PLANNING			
		S. Harvey 2 Greenfield Way, Storrington, West Sussex, RH20 4PY T: 07833 178649 E: simontharvey@hotmail.com	
Client: Mr & Mrs Messenger			
Project: Single storey rear extension and first floor side extension & alterations			
Address: 253 Church Lane, Lymminster, West Sussex, BN17 7QJ			
Drawing Title: PROPOSED ELEVATIONS			
SHEET 1 OF 2			
Drawing Number: 28_105			
Date: November 2018		Scale: 1:100 @A3	
ARUN DISTRICT COUNCIL LY/4/19/HH

Project: Single storey rear extension and first floor side extension & alterations

Address: 253 Church Lane,
Lymminster,
West Sussex,
BN17 7QJ

PROPOSED REAR ELEVATION
(SOUTH)

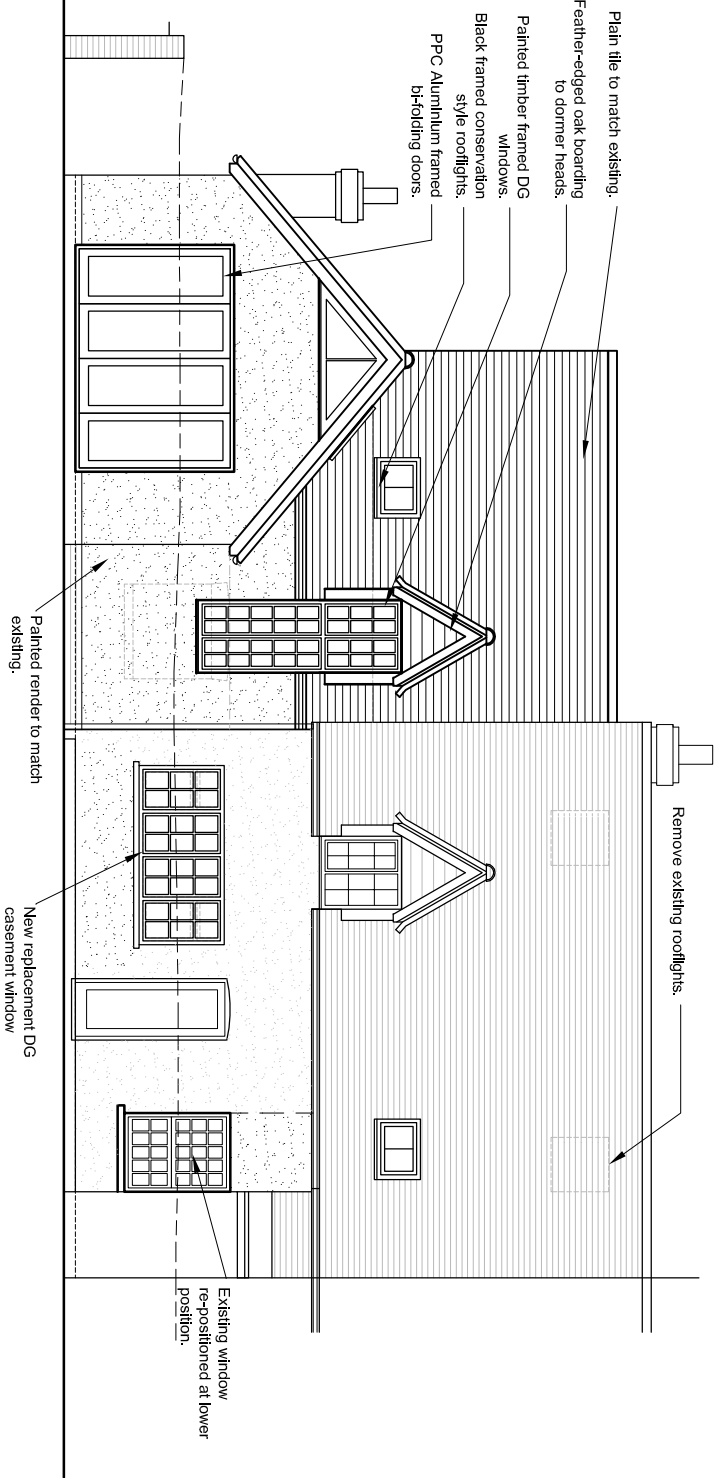
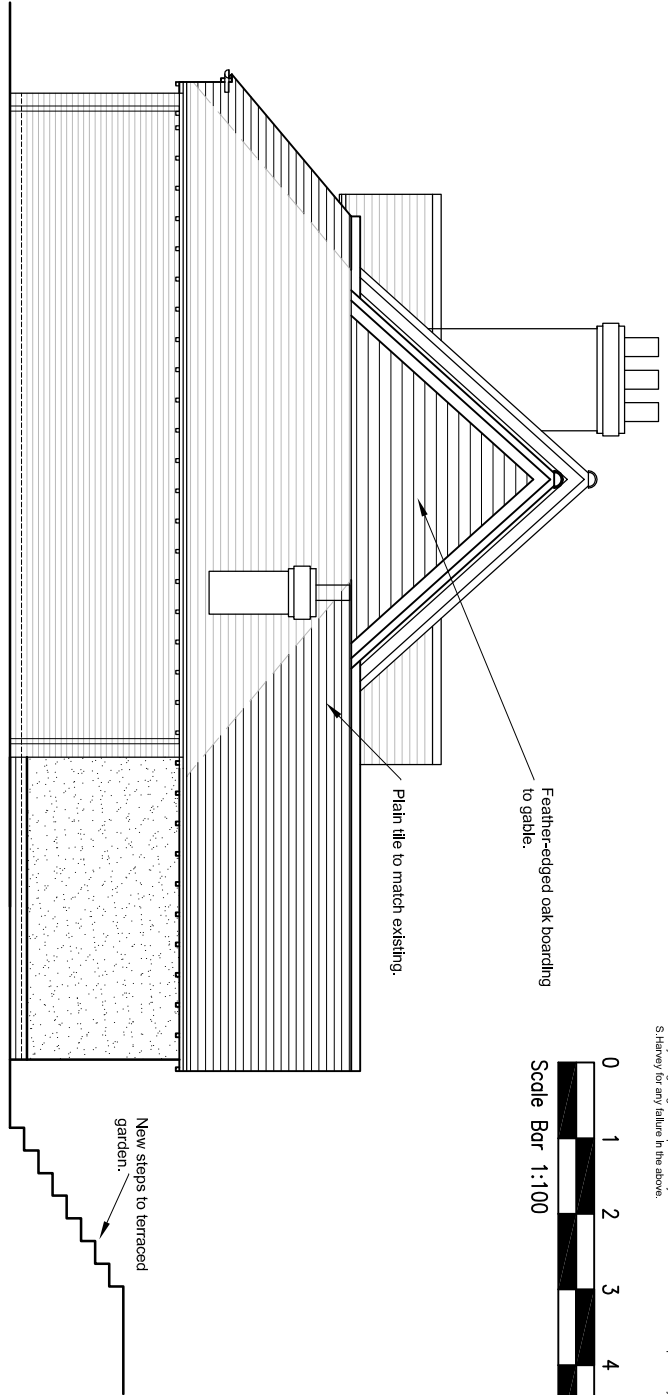
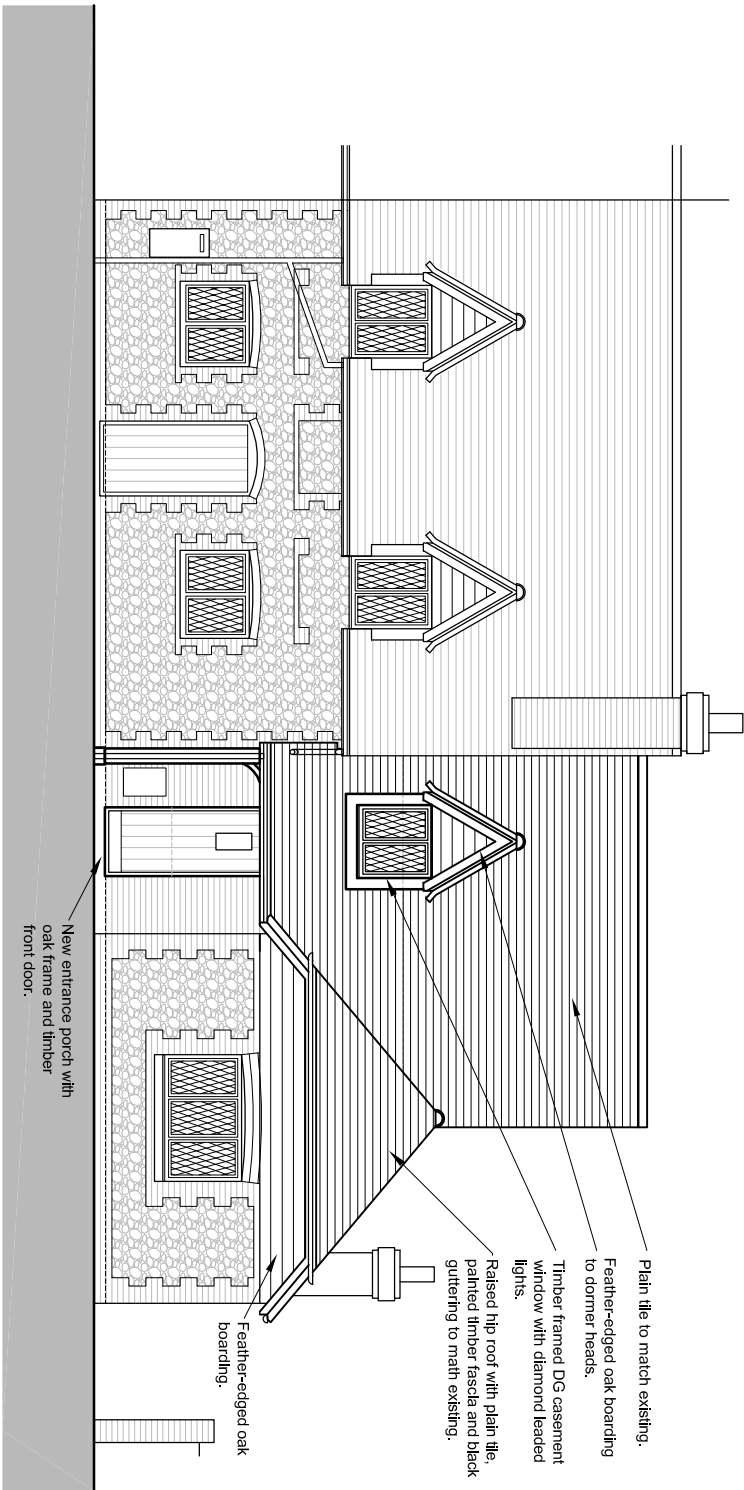
A - Further to Officer's comments, Scheme revised to substantially reduce first floor extension.
04.06.2019
